RECONVENED MEETING OF ARGYLL AND BUTE LOCAL REVIEW BODY

17/0007/LRB

**Amendment of Condition 2 of Planning Permission 17/01092/PP
granted on 18/07/17 (requirement for existing boundary walls to be
set back by 2 metres)**

FURTHER INFORMATION REQUESTED FROM PLANNING AUTHORITY RELATIVE TO 17/0007/LRB

Project: U.C. No.10 Kilmelford -
 Degnish Farm Road.
 Loch na Cille Bridge replacement

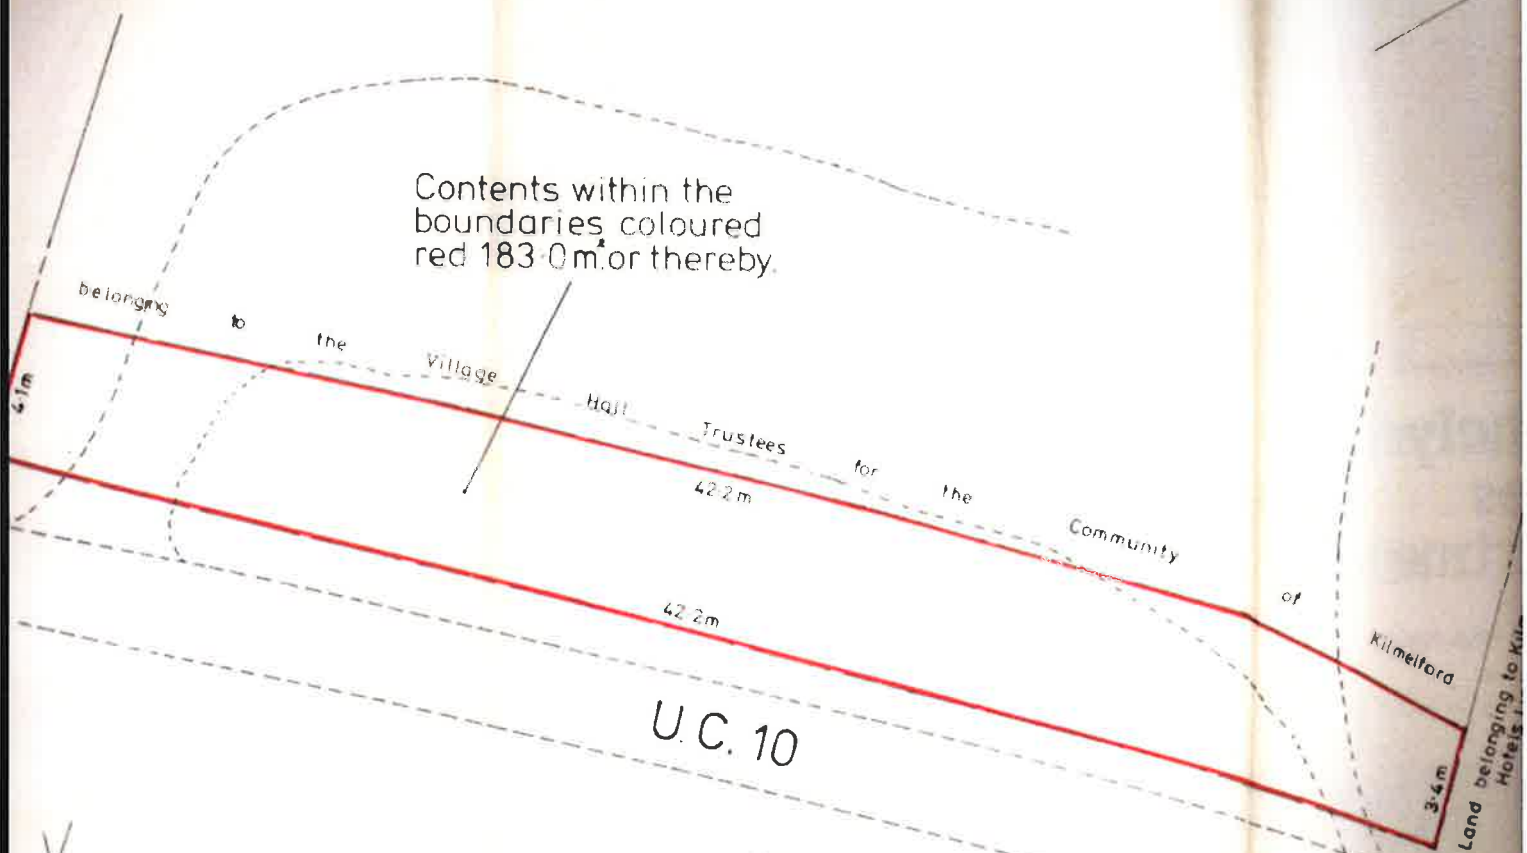
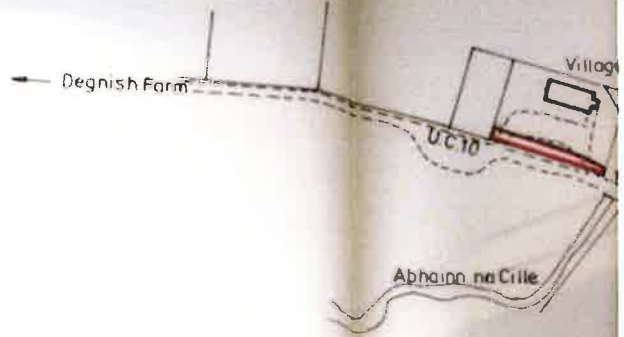
Although the Village Hall Trustees for the Community of Kilmelford acquired 0.432 acre of ground, in 1954, you may be aware that Strathclyde Regional Council subsequently purchased 183 square metres of those subjects, in 1985.

I attach hereto a scanned copy of the title plan relative to the Statutory Conveyance in favour of Strathclyde Regional Council, for your information.

I assume that you will be able to assess whether or not the land to which your enquiry relates forms part of the plot of ground acquired by Strathclyde Regional Council. I would need to obtain a copy of the Ordnance Survey Map for the area in order to assess if the plot of ground was used for road widening and now is included within the surfaced area of the public road.

REV	DESCRIPTION	DATE
	PROPOSED DWELLING FOR WILLIE BEATTIE @ KILMELFORD, ARGYLL -	
DRAWING		
PRIVATE ACCESS & PROPOSED WALL REALIGNMENT -		
DRAWN BY	SCALE	
ARME	1:200	
DATE	CHECKED	
JUNE 17		
DRAWING NO	REV	
AR/239/B/08

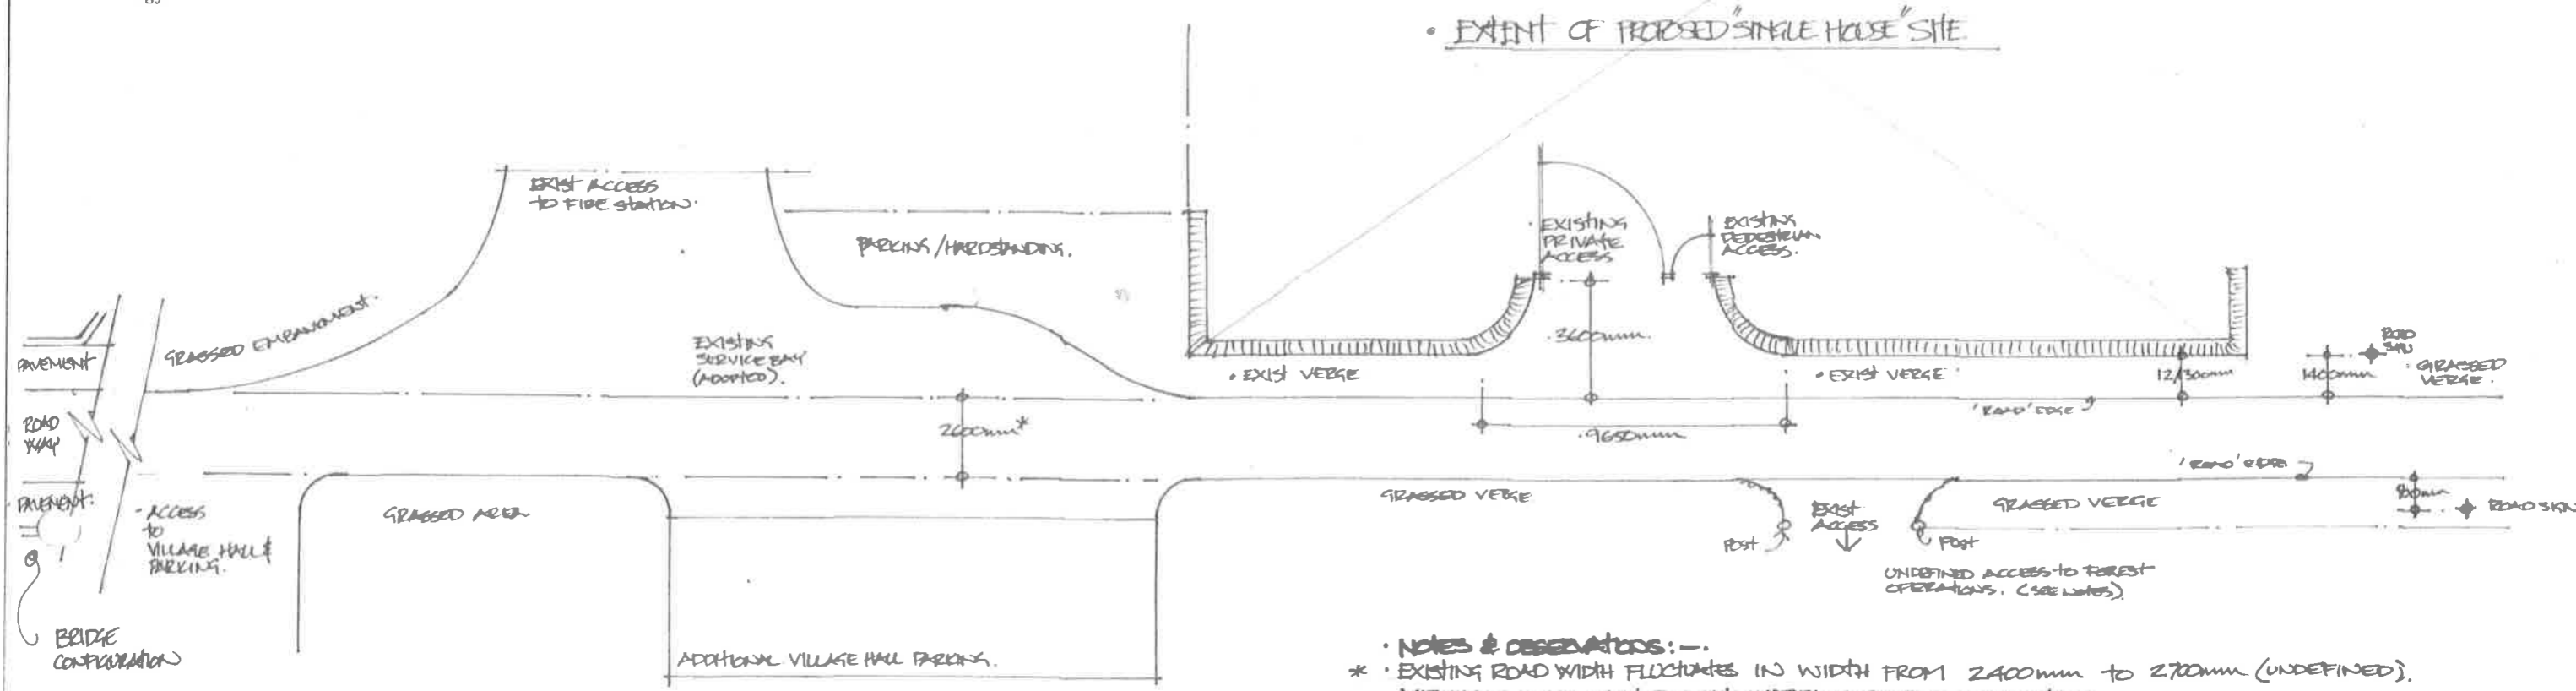
My client has sought the Review of the need for a service bay appended to his site entrance by the utilization of the EXISTING and ADJACENT Service Bay adjacent to his Site (in front of the Fire Station) as detailed on plans submitted earlier and again with this submission.

The Main point of the review is that there is a generous service bay effectively appended to the site For Clarity , my client is not and has never been minded to sponsor a service bay on the opposite side of the road. in front of the fire station, which would facilitate my clients site and the needs of service providers perfectly well.

With regard to the concern raised about visibility, attention is drawn to the need for the existing ground level within the Application Site to raise the Existing Ground Level some 150-200mm, this to compensate for an elevated Ground Floor Datum required in terms of future Flood Risk. All contained and detailed within the Planning Approval. Ref 17/01092. This will bring the effective height of the wall to less than the statutory requirement, and so offer no restriction to clear site lines.

It is hoped that there will be an opportunity for the Roads Dept to clarify what is meant by "Setting the Wall back by 1000mm", from existing position or from the road "edge".

SITE & PROXIMITY PLAN

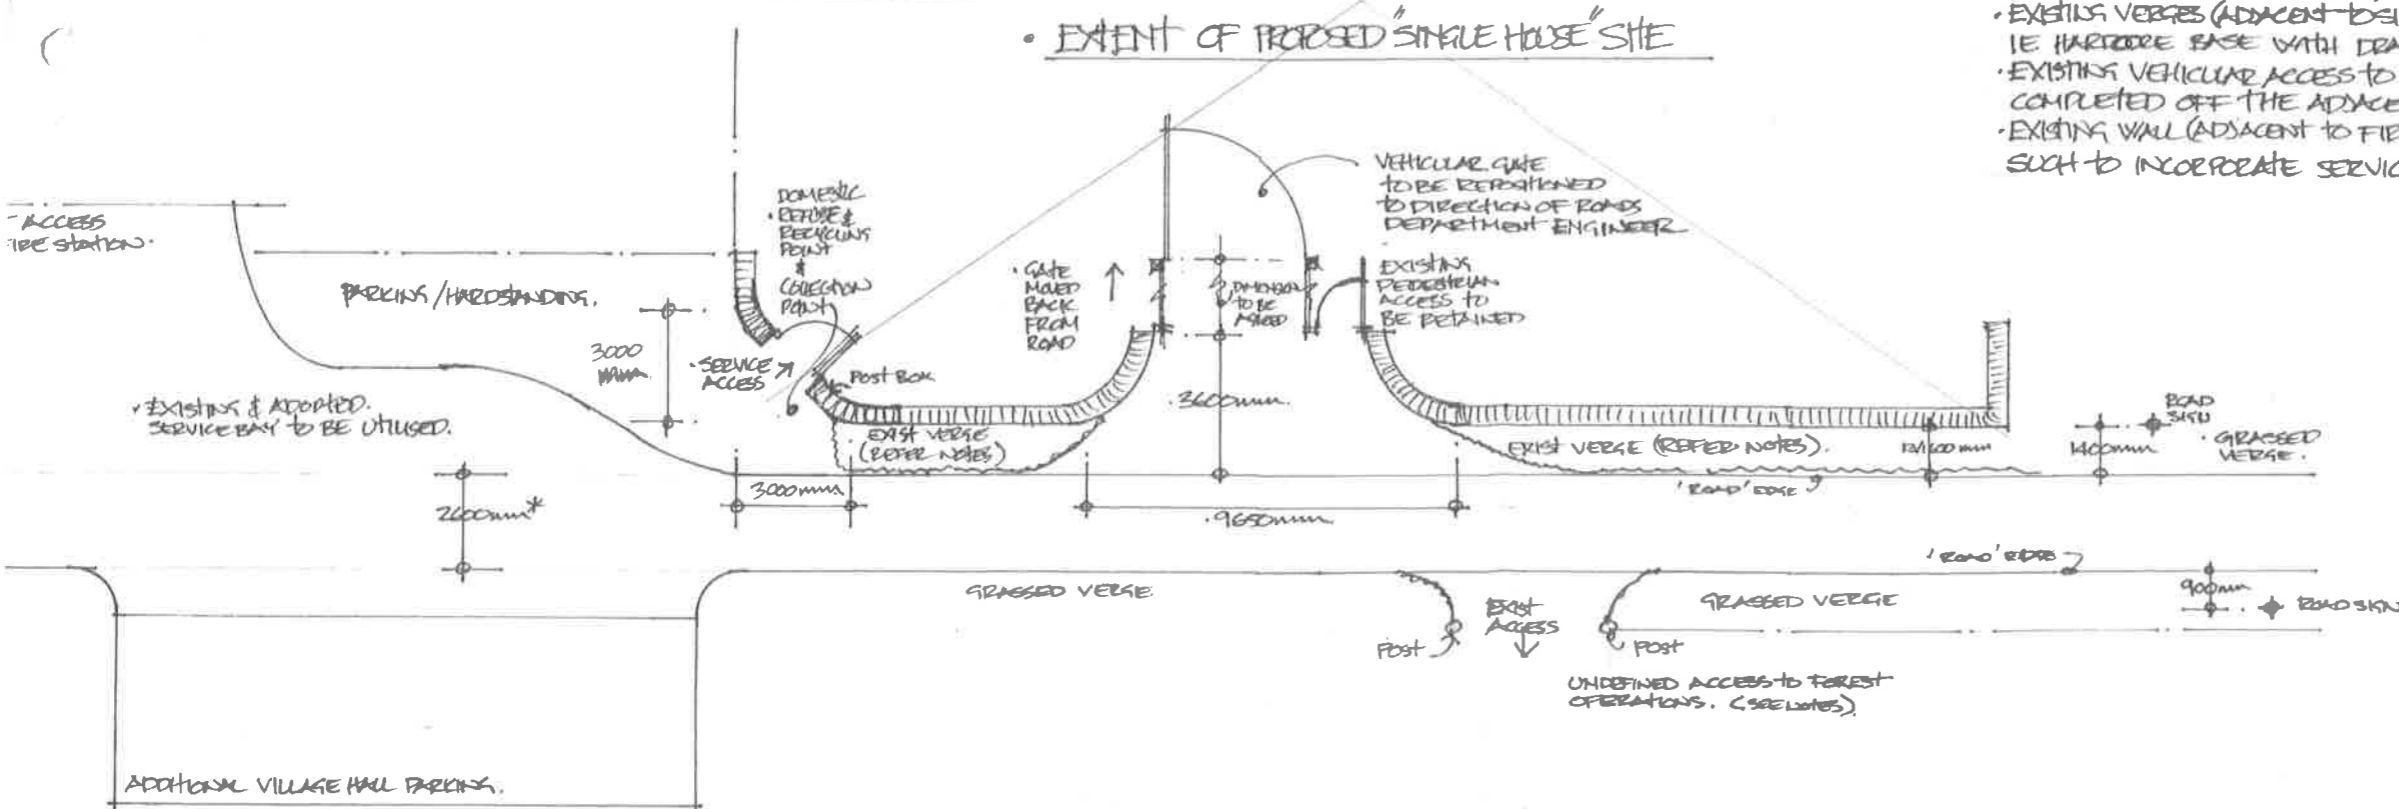
Secondarily is the debilitating area required from this already constrained site by a further service bay, a few meters along the road from the existing one.

Site and Proximity Plan showing effective special requirement of an Additional Service Bay. AR/239/B/02 rev B.
